SB0071 (Supersedes SB0071 [806])

ES SERVICE BULLETIN

Affected Equipment: All YPAL MOD "D" & "E"
Packaged Rooftop Units

Subject: Transducer Operation

SETTINGS FOR "DUCT STATIC SNS SPAN OF 0 TO 2.5" WC

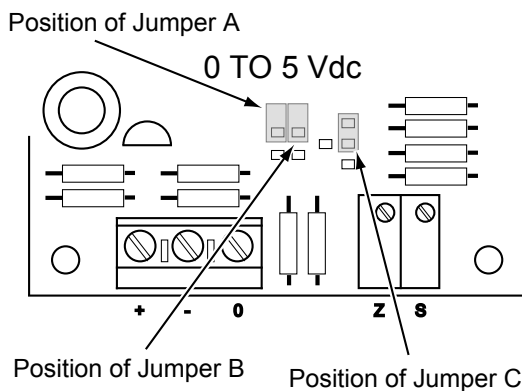
5. For the Return Static Transducer remove wire 307 of the harness identified as "RETURN STATIC" from terminal block CTB4 and reconnect the wire to terminal block CTB3.
6. Check for 24-VAC between terminal + and – at the Return Static Transducer.
7. Verify the proper calibration of the transducer as follows:
 - a. For the duct static transducer remove all the tubing from the transducer. Identify which tube was on the High and Low connections of the transducer. The voltage output between terminals O and – at the transducer should be 12 to 14 millivolts DC. If this is not the case replace the transducer with part number 025-35808-002. When the new transducer is installed it must be configured based on the application, see the figure below:

BUILDING PRESSURE TRANSDUCER CONFIGURATION
(- 0.625 TO + 0.625 w.c.)

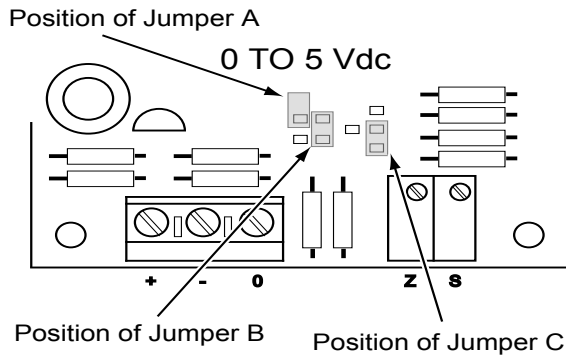
- b. For the building pressure and return fan transducer remove all the tubing from the transducer. Identify which tube was on the High and Low connections of the transducer. The voltage output between terminals O and – at the transducer should be 2.5 volts DC. If this is not the case replace the transducer with part number 025-35808-002. When the new transducer is installed it must be configured based on the application, see the figure below:
